HULL NO. 165  
DECK PLANS

Great Lakes Engineering Works

S/S "Bequa"

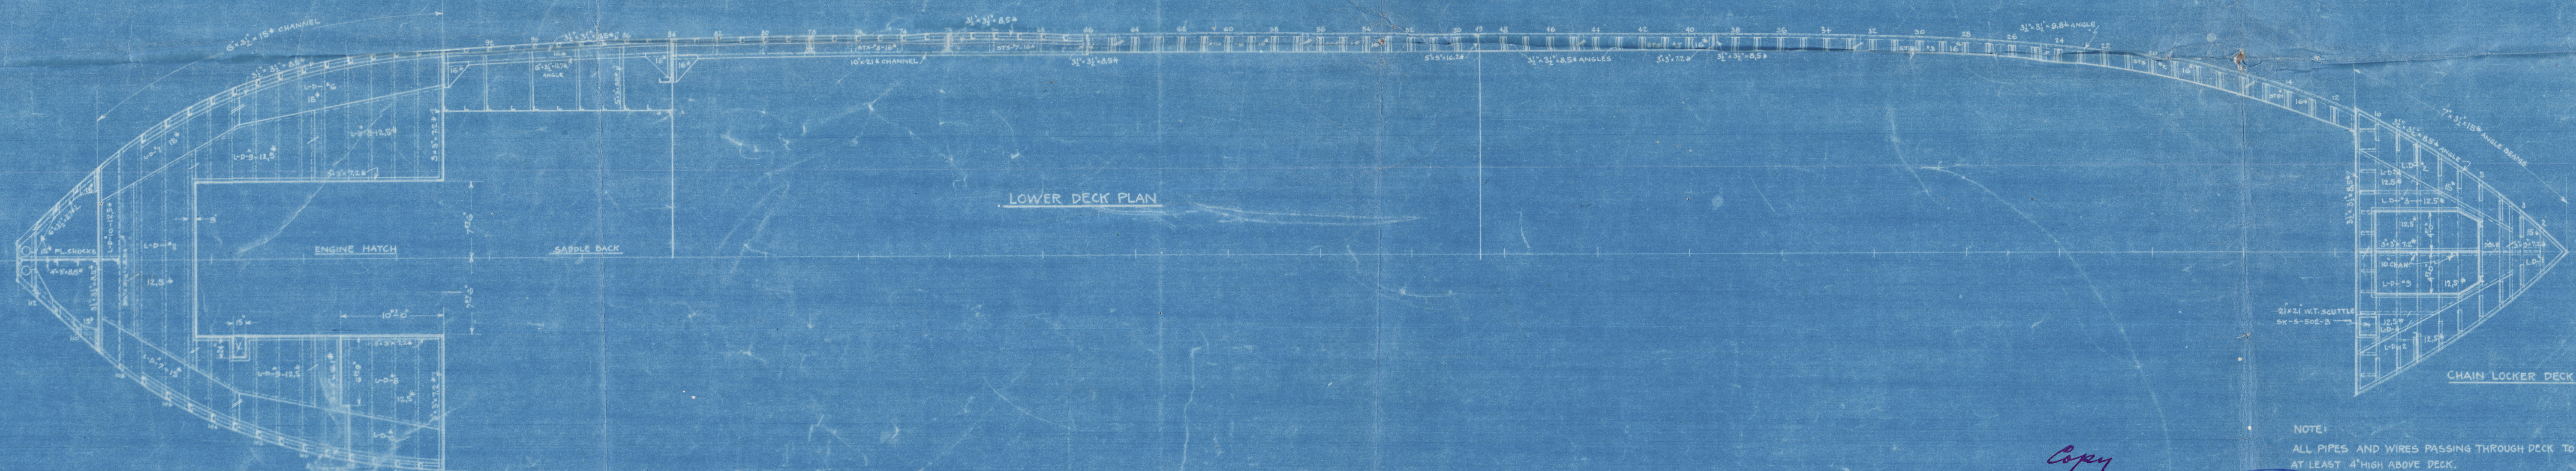
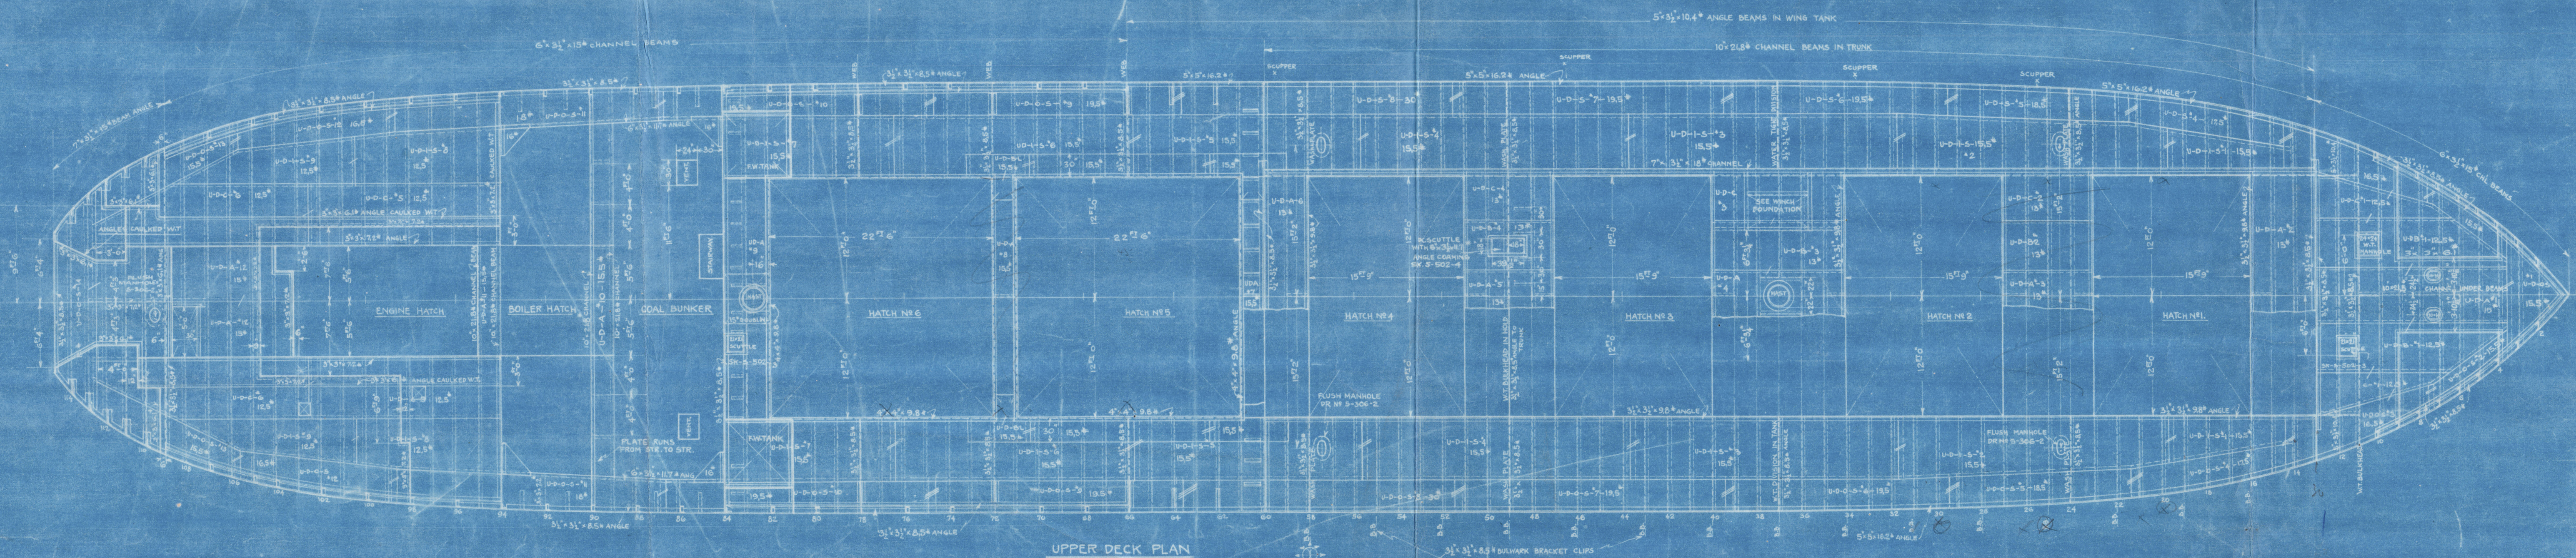
DATE	ITEM
APRIL 25-16	ANGLE AT UPPER DECK HATCHES UNDER POOP CHANGED TO 4" x 4" x 1/2"
" "	DOUBLING PLATES AT UPPER DECK HATCH NO. 5 ADDED
MAY 6-16	MAIN MAST SHIFTED 4" FORWARD
MAY 18-16	NEW SKETCH OF 21" x 21" SCUTTLE AT ENDS & 15" x 30" SCUTTLE AMIDSHIP
" "	SCUTTLE IN STEERING ENG. ROOM CHANGED TO W.T. MANHOLE
" "	GIRDERS & LIGHT CABINETS UNDER POOP DECK ADDED
